SAN MATEO-FOSTER CITY SCHOOL DISTRICT FACILITIES AND CONSTRUCTION ADDENDUM NO.2

Date: May 6, 2026

**Project: FIESTA GARDENS/TURNBULL CHILD DEVELOPMENT CENTER FIRE ALARM
UPGRADE**

Bid No.: 26-07

FA2.1

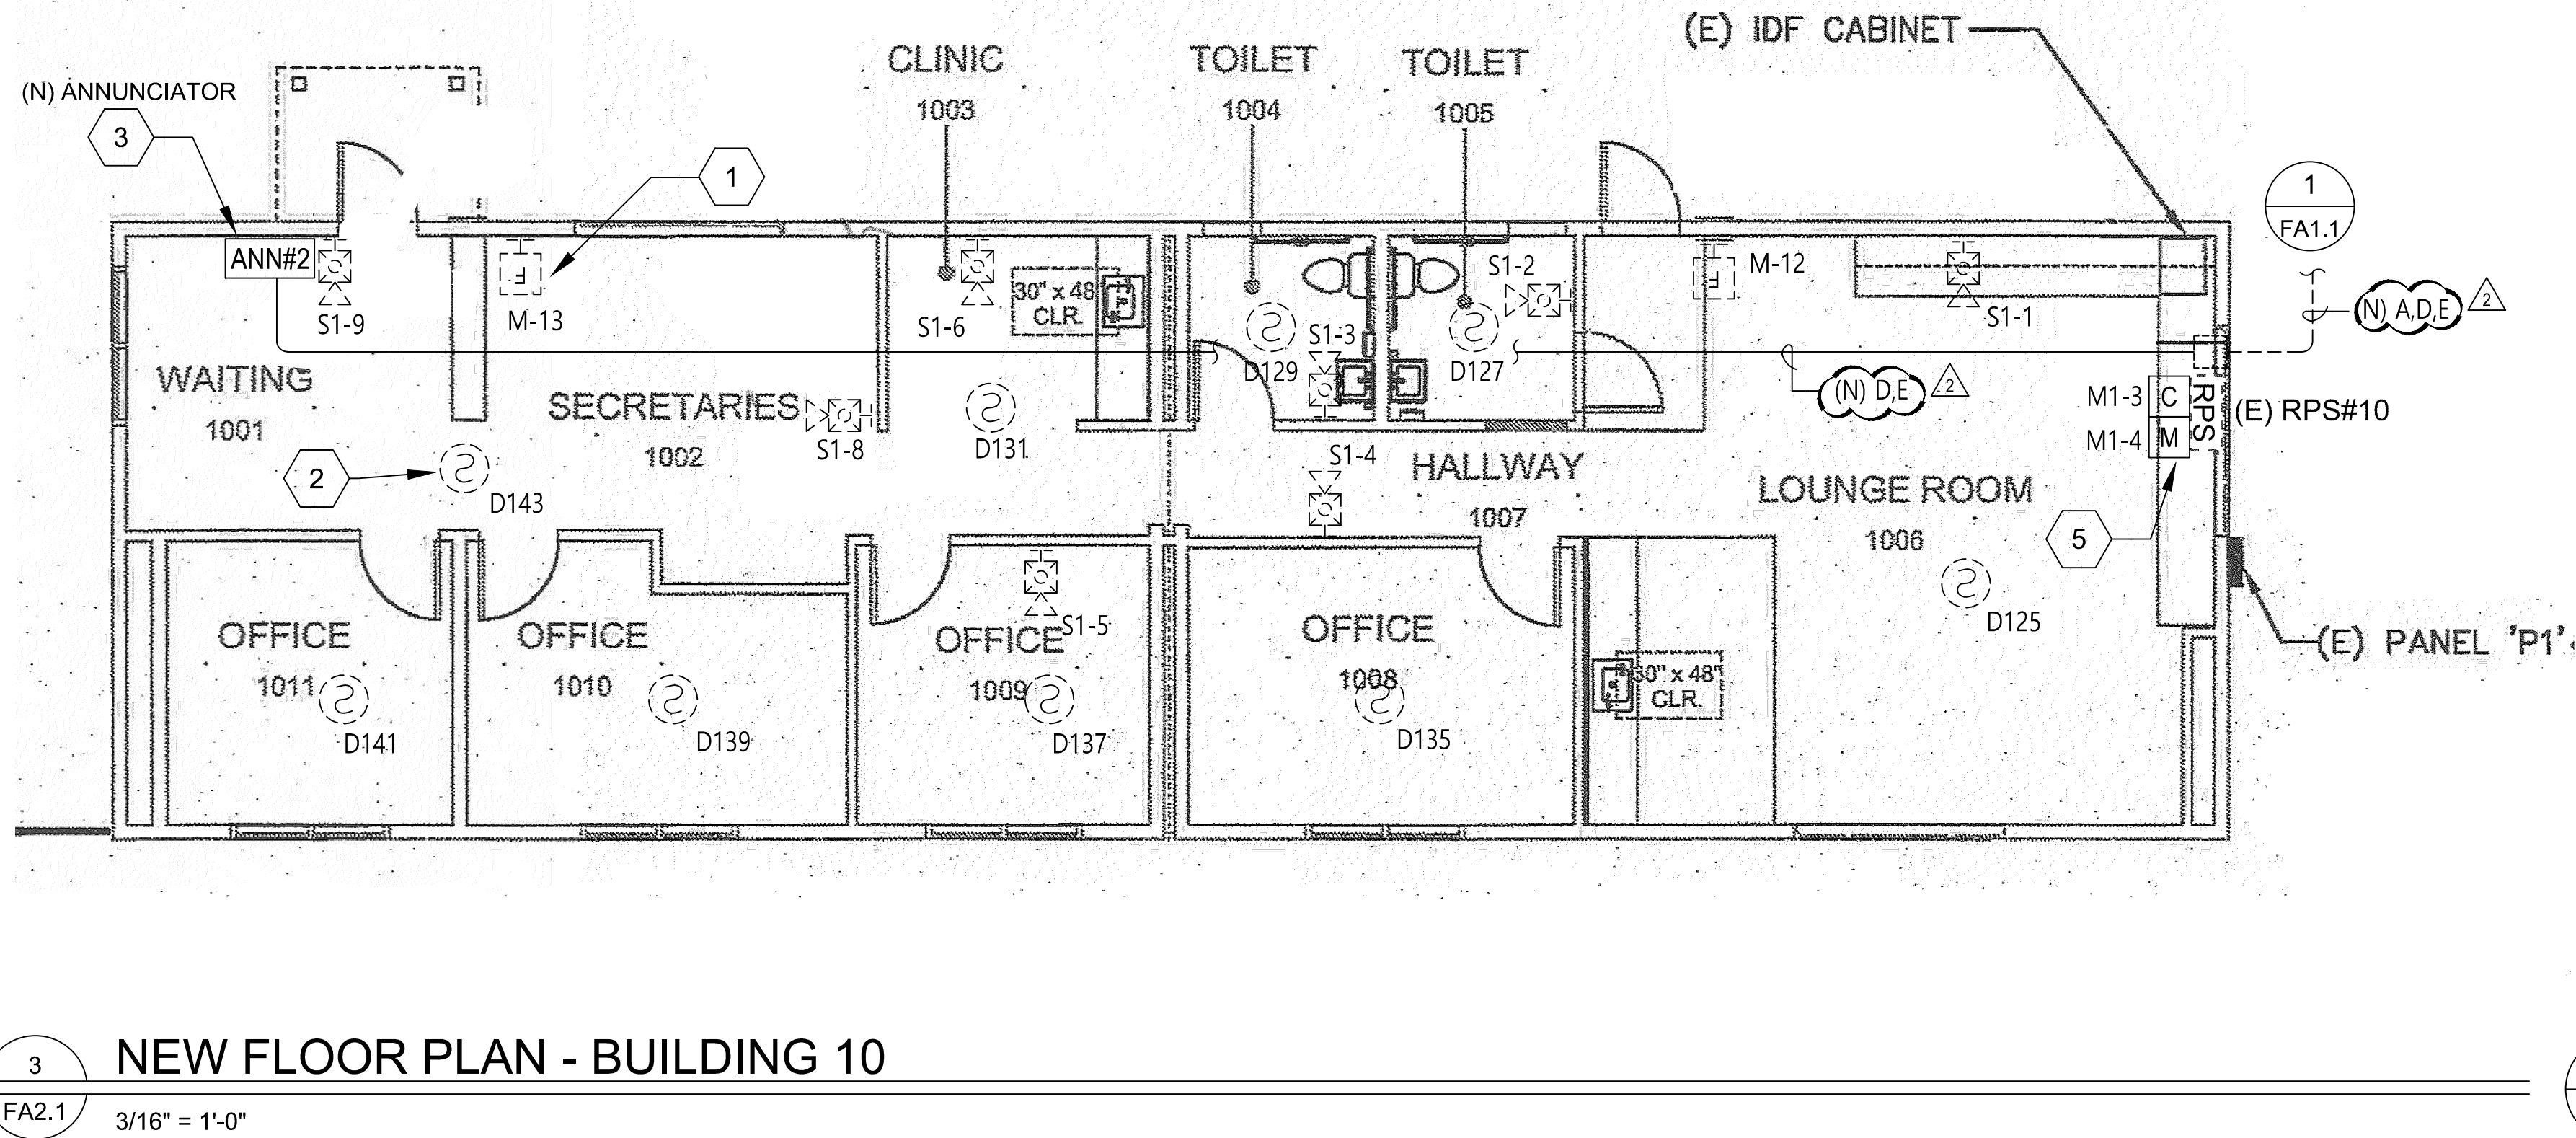
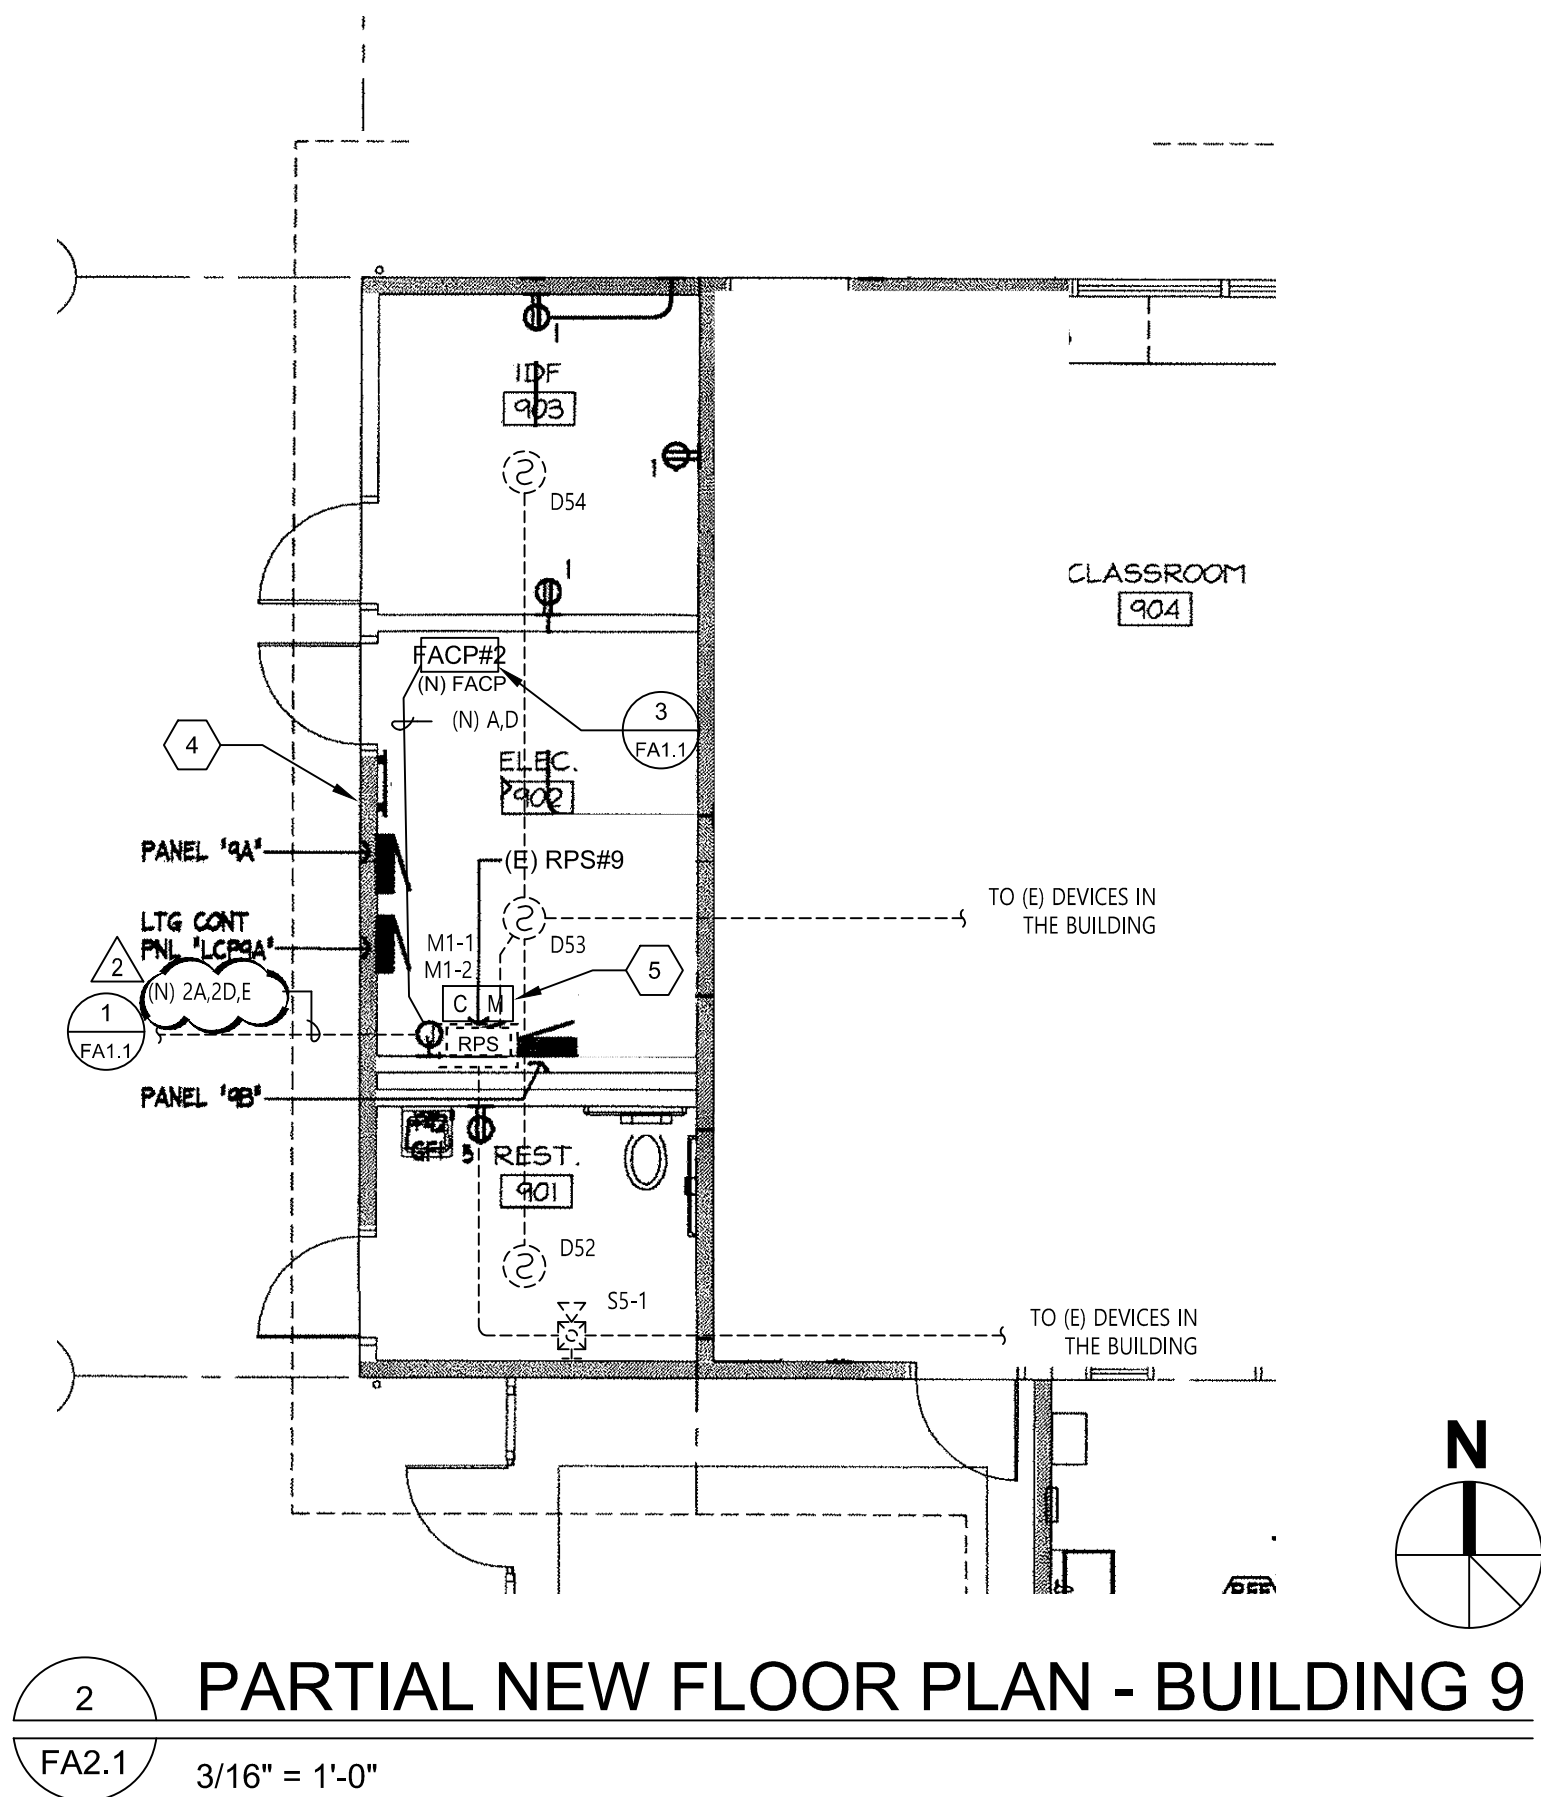
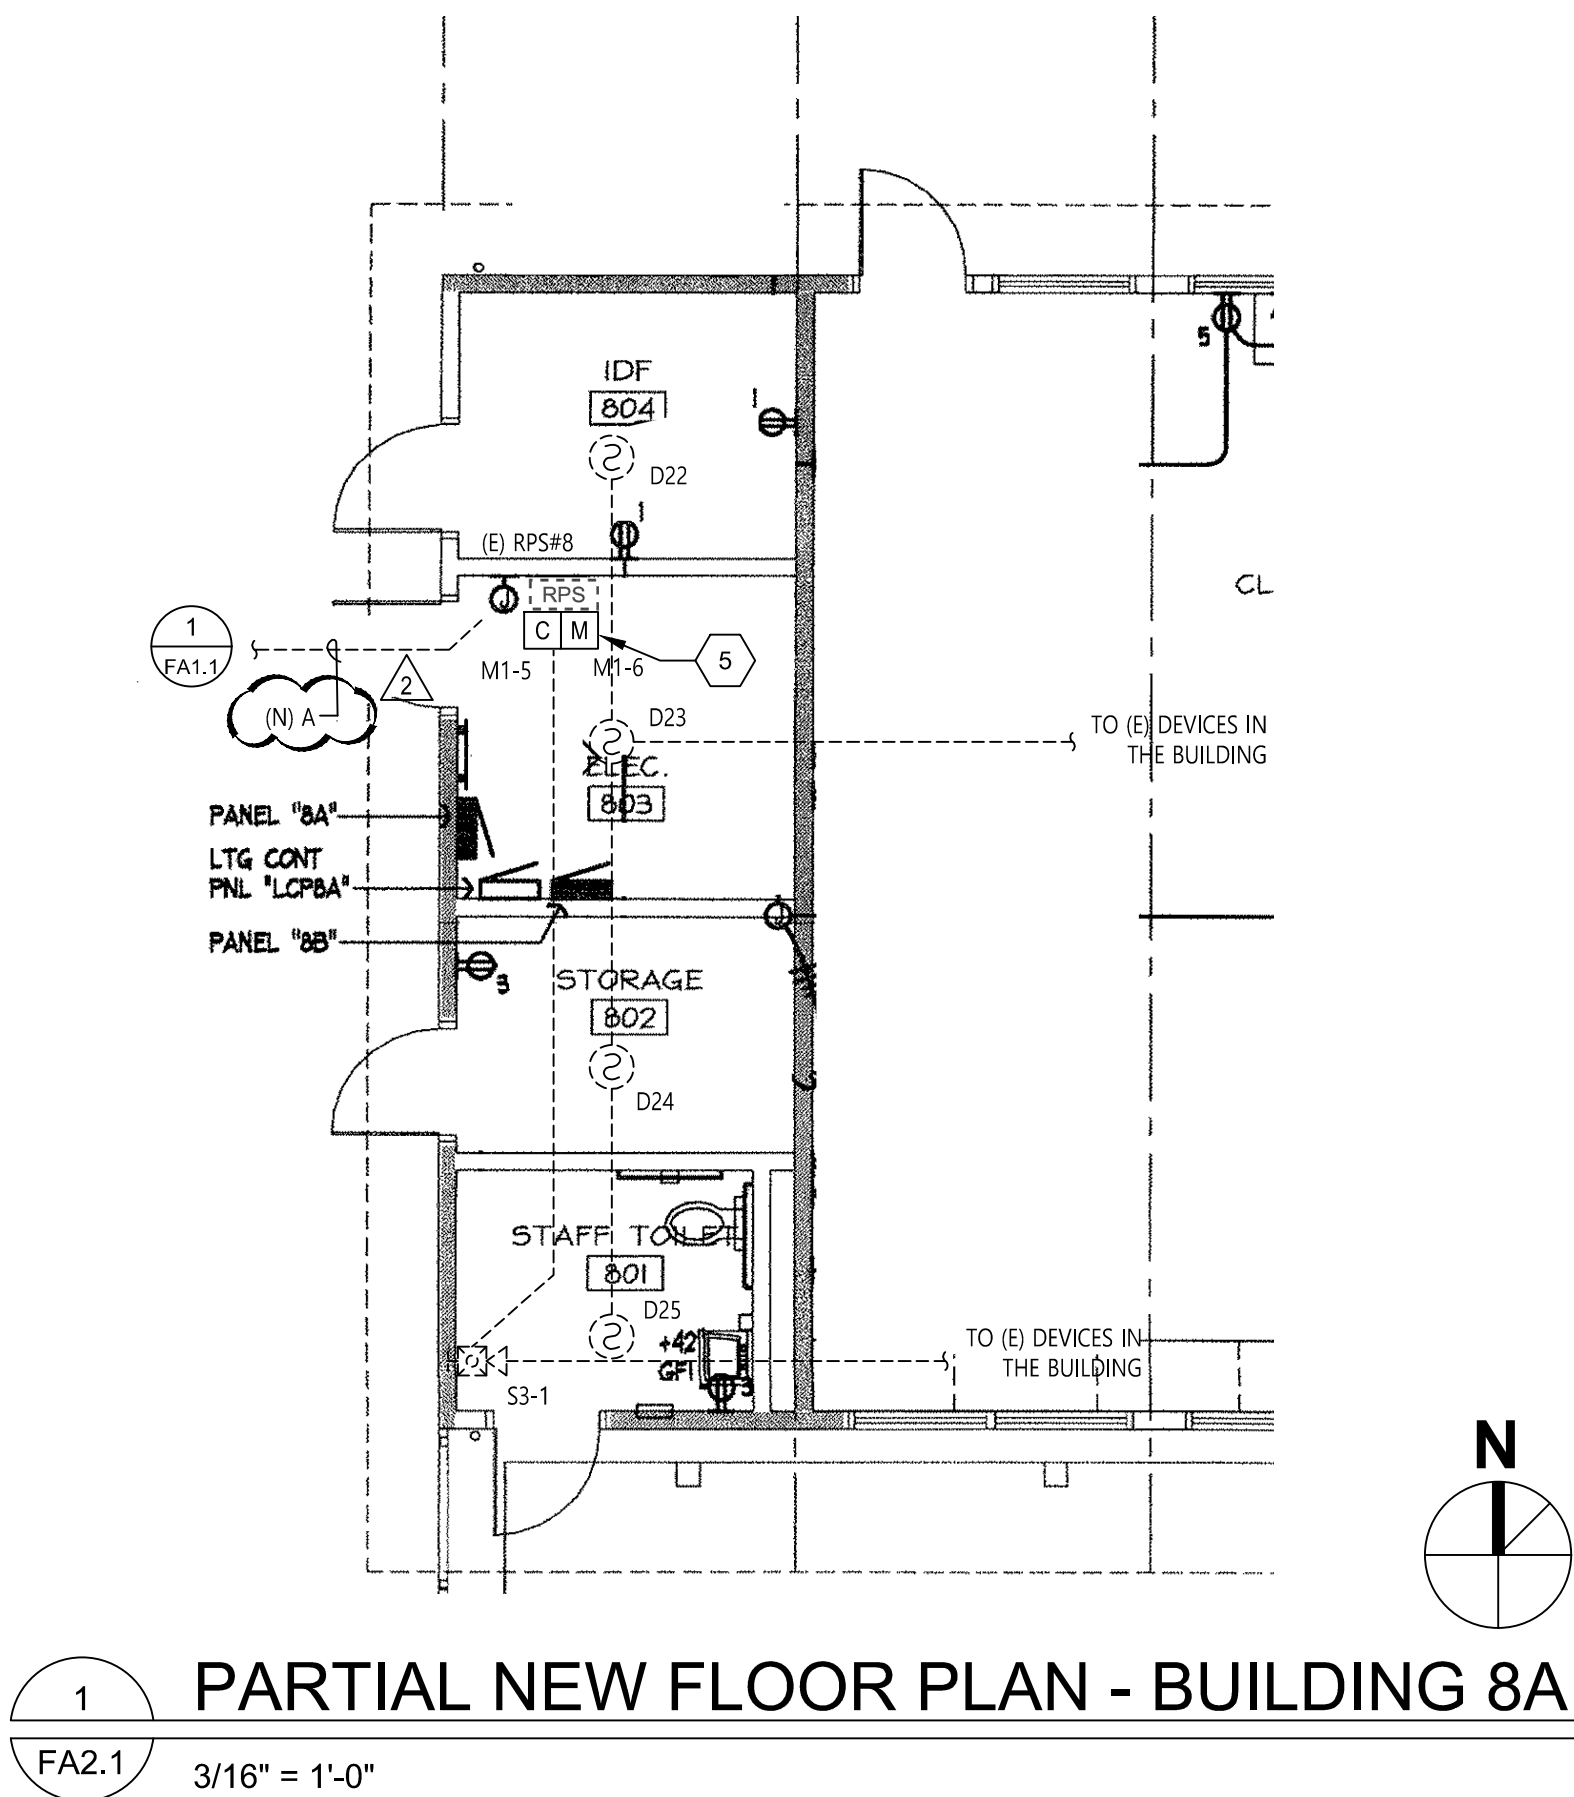
Reference: Drawing FA2.1 NEW FIRE ALARM FLOOR PLANS

1. Revised cables call out on the floor plans.
2. Added cable schedule to the sheet.

CABLE SCHEDULE:

- A - (1) #14 UNSHIELDED TWISTED PAIR FOR SIGNALING LINE CIRCUITS.
B - (2) #12 FOR STROBE CIRCUITS
C - (1) #12 UNSHIELDED TWISTED PAIR FOR NAC TRIGGER TO RPS
D - (1) 6-STRAND SINGLE - MODE FIBER OPTIC CABLE
E - (2) #12 ANNUNCIATOR POWER
